UNITED STATES PATENT AND TRADEMARK OFFICE

Office Action Summary

10/534,178

DETAILED ACTION

FIG.1B

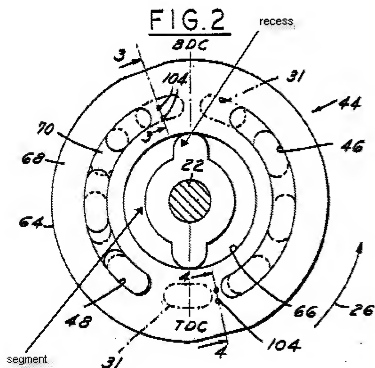
5. In Re claim 1, with reference to figures 1B and 2 depicted above, Tovey discloses a control plate (44) for an axial piston machine (12) having at least two control openings (46), (48) by means of which cylinder bores (30) of a cylinder drum (28) rotatably mounted (on shaft (22)) in housing (14) are alternately connected, on rotation

7. In Re claim 4 and 12, Figure 1B of Tovey depicts a radial edge (lip that is pointed to by the arrow associated with label (44)). The lip surrounds the plate around the outer edge and therefore is connected to the high-pressure connection and the low-pressure connection in the region of all the control openings.

9. In Re claim 8, with reference to figures 1B and 2 depicted above, Tovey discloses an axial piston machine (12) having a cylinder drum (28) which is rotatably mounted in a housing (14) and in which are made cylinder bores (30) in which pistons (32) are axially displaceably arranged, the cylinder bores (30) having openings (31) towards and end side of the cylinder drum (28) are alternately in connection with a high-pressure connection (48) and a low-pressure connection (46) via at least two control openings (46), (48) of a control plate (44), the control plate (44) having through opening (66) wherein:

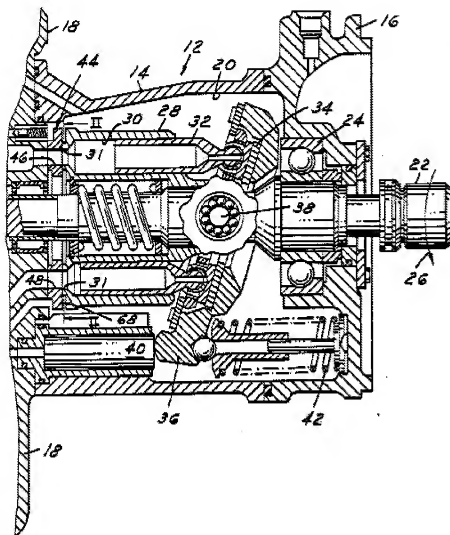
- the radially inner edge (depicted by label 66 pointer) of the control plate (44) is designed as a centering surface around shaft (22)
- the centering surface comprising plurality (2) of partial surfaces formed on segments (depicted above in Figure 2) of the inner edge of the control plate (44) which extend radially inward into the through opening (66) as depicted in Figure 2, and are separated by recesses as depicted

6. In Re claim 3, Figure 2 of Tovey depicts the thickness of the segments is substantially the same as the depth of the recesses, and they also have a finite width. The recess transforms into a gap between the shaft (22) and the radially inner edge (depicted by label 66 pointer) after assembly of the machine.

8. In Re claim 6, Figure 2 of Tovey depicts the thickness of the segment is less than the thickness of majority of the plate.

11. In Re claim 11, the radial extend of the recess is greater than the radial extend of the segment as depicted in Figure 2 of Tovey.
